SERVICE BULLETIN
NO:06011-R3

MODELS : TX-SR674 / TX-SR804 / DTR7.7

SUBJECT : Picture Interruption in output of 1080P signal via HDMI on Playstation 3

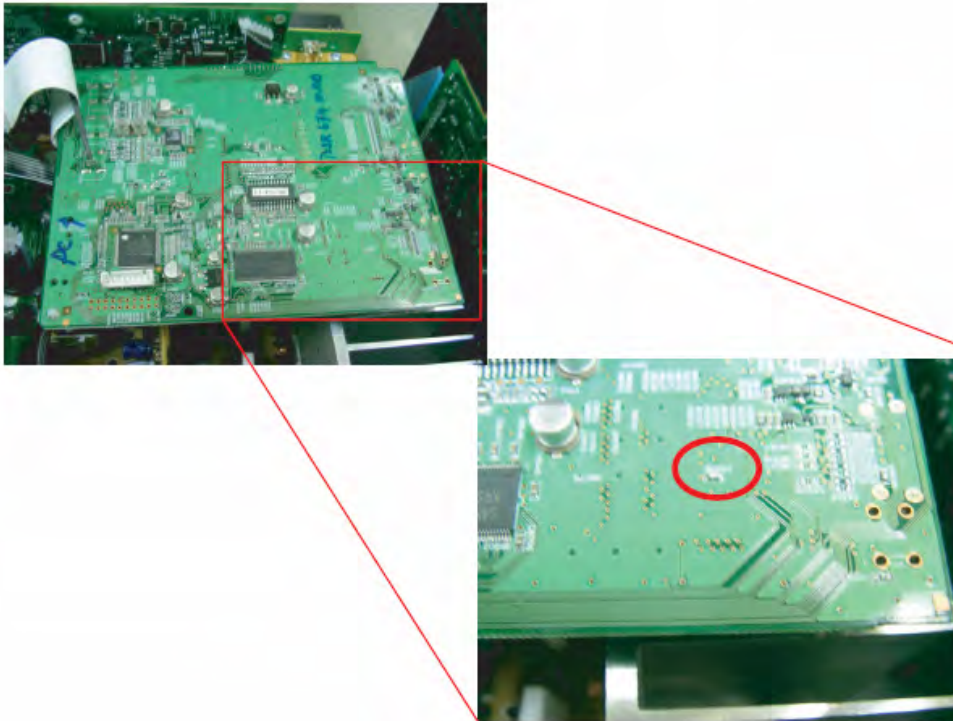
Video output is often interrupted when 1080P signal outputs via HDMI because of authentication error.

Monitor detects problem by mistake because of unstable pixel clock for HDMI output IC.

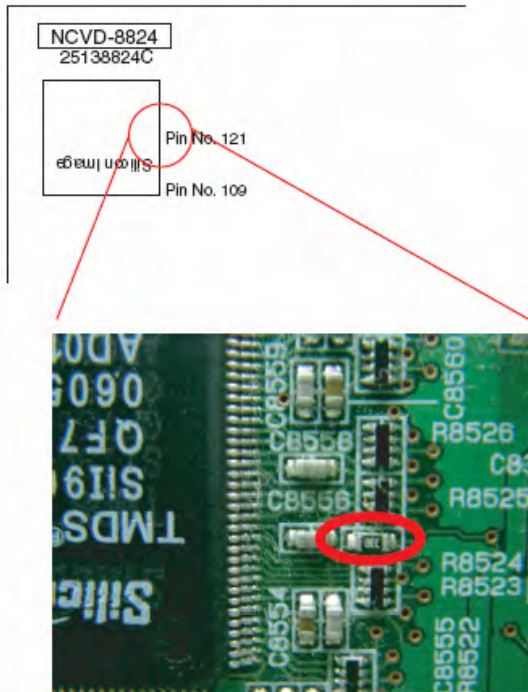
C8428 Remove this capacitor.

R8524 Change Resistance Value from 33ohm to 10ohm.

- 1) Remove Capacitor C8428 on HDMI Board NAVD-8824.
- 2) Change Resistor at R8524 from 33 ohm to 0ohm on HDMI Board NAVD-8824.

The resistance value of R8524 was changed to 22ohm first and then to 10ohm again. and finally to 0ohm . 0ohm is the best and 10ohm is better, but 10ohm and 22ohm are also effective. Therefore, when 22 or 10 ohm Resistor is mounted at R8524, it is not necessary to replace it by 0ohm Resistor as long as the unit has no problem.
